NEW LAGUN BUSHINGS

Proper assembly of the parts is essential to ensure proper function. The original Bushing style allowed the Arm to be installed upside down.

INSTALLATION EXAMPLES

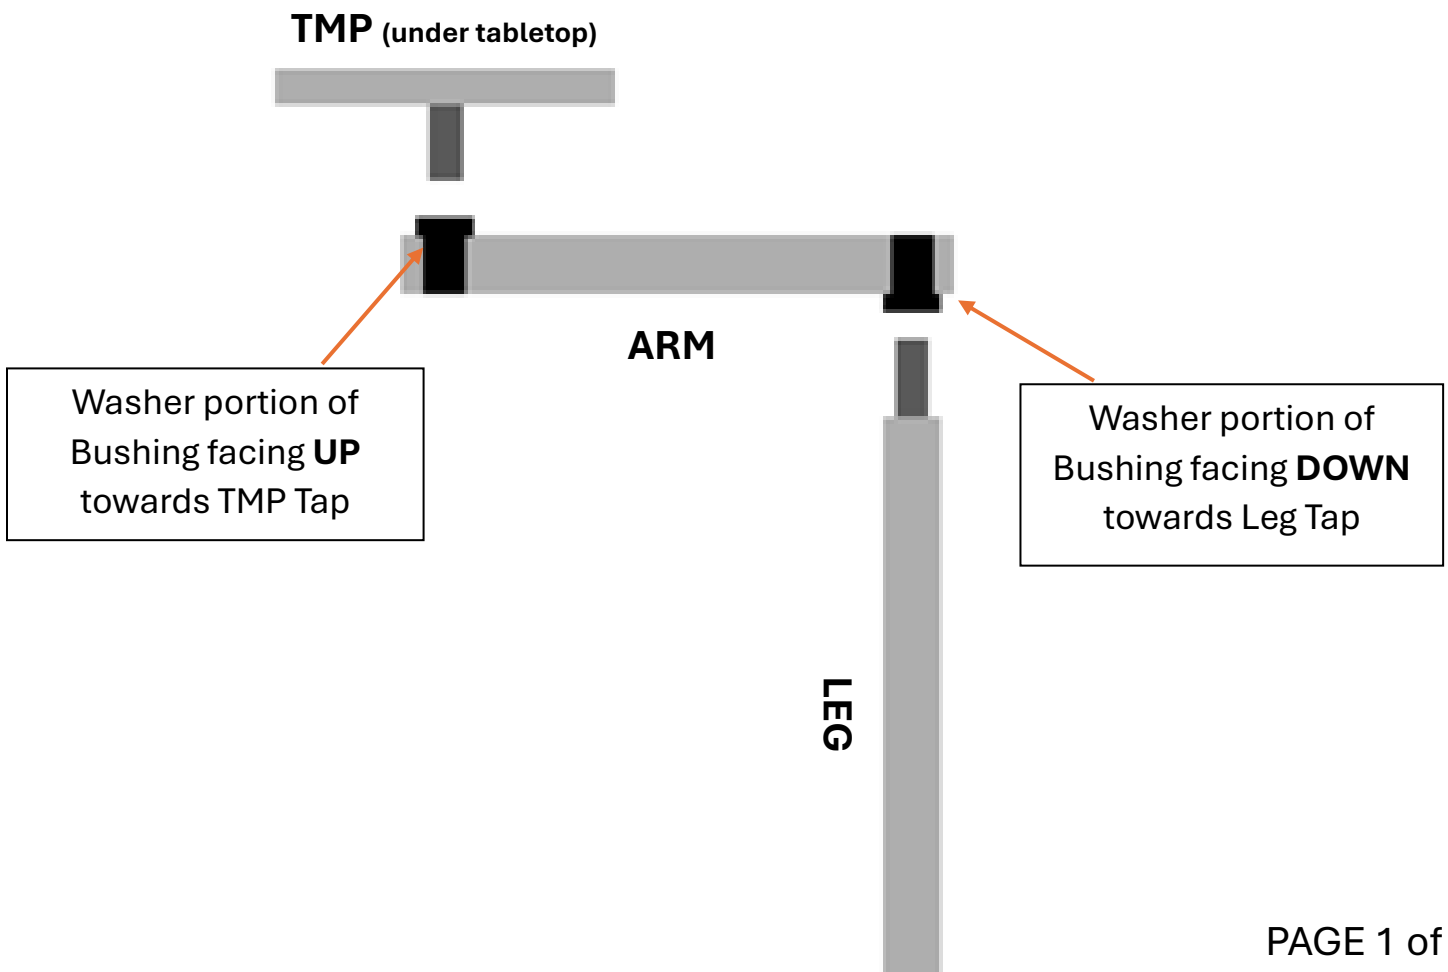
New Bushings are being implemented to include 'teeth', which will prevent the Arm from being assembled upside down.

**ARM w/original bushing style =
UPSIDE DOWN**

**NEW BUSHING STYLE WILL NOT ALLOW
ARM TO BE INSTALLED UPSIDE DOWN.**

Washer portion of Bushing
faces towards Taps

Tap is inserted flush into Bushing

Washer portion of
Bushing facing **UP**
towards TMP Tap

Washer portion of
Bushing facing **DOWN**
towards Leg Tap
